Access Compliance Report

Public Rights-of-Way

(Curb Ramps)

Intersection ID: 44452	Main Street: BAYVIEW_PY	Cross Street: BUCKHORN_ST	Location: SE
ADA ID: F2C4D21B89E1	Ramp Type: PerpDiag	Initial Pass/Fail: Fail	Overall Compliance: No
		Severity Score: 17.5

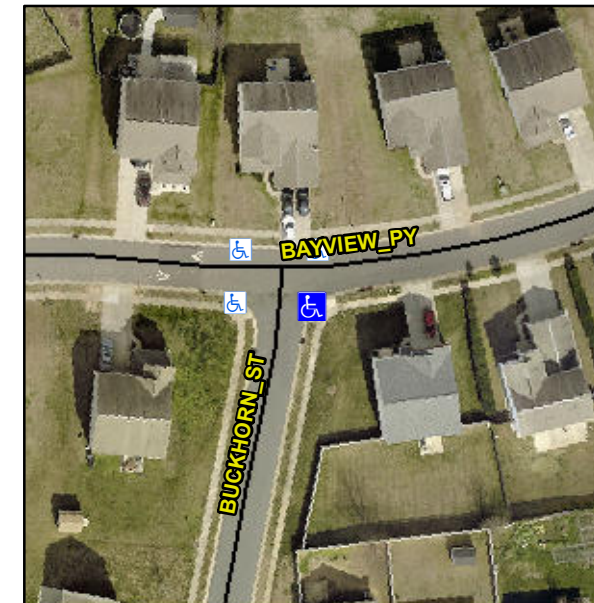
Not Found, R304.5.1

Compliance	Description	Data	Compliance	Description	Data
N/A	Ramp Length (in)	49.5	Yes	Ramp Slope (%)	7.0
No	Ramp Width (in)	35.0	Yes	Ramp XSlope (%)	2.0
N/A	Flare Type LT	N/A	N/A	Flare Type RT	N/A
N/A	Flare Slope LT (%)	N/A	N/A	Flare Slope RT (%)	N/A
N/A	Flare Traversable LT?	N/A	N/A	Flare Traversable RT?	N/A
N/A	Landing Length (in)	N/A	N/A	DWS Provided?	N/A
N/A	Landing Width (in)	N/A	N/A	DWS Contrast?	N/A
N/A	Landing Slope (%)	N/A	N/A	DWS Length (in)	N/A
N/A	Landing X Slope (%)	N/A	N/A	DWS Full Width?	N/A
N/A	Landing Curb? (Y/N)	N/A	N/A	DWS Offset (in)	N/A
N/A	Shared Landing?	N/A			
N/A	Gutter Ponding?	N/A	N/A	Gutter Slope (%)	N/A
N/A	Gutter Lip Ht (in)	N/A	N/A	Gutter X Slope (%)	N/A
N/A	Painted X Walk1?	No	N/A	Painted X Walk2?	No
	X Walk 1 Direction	To N		X Walk 2 Direction	To W
N/A	X Walk 1 Width (in)	N/A	N/A	X Walk 2 Width (in)	N/A
	X Walk 1 Slope (%)	1.2		X Walk 2 Slope (%)	3.7
	X Walk 1 X Slope (%)	2.3		X Walk 2 X Slope (%)	0.1

Remove & Replace Curb Ramp With Two New Directional Ramps or Equivalent.
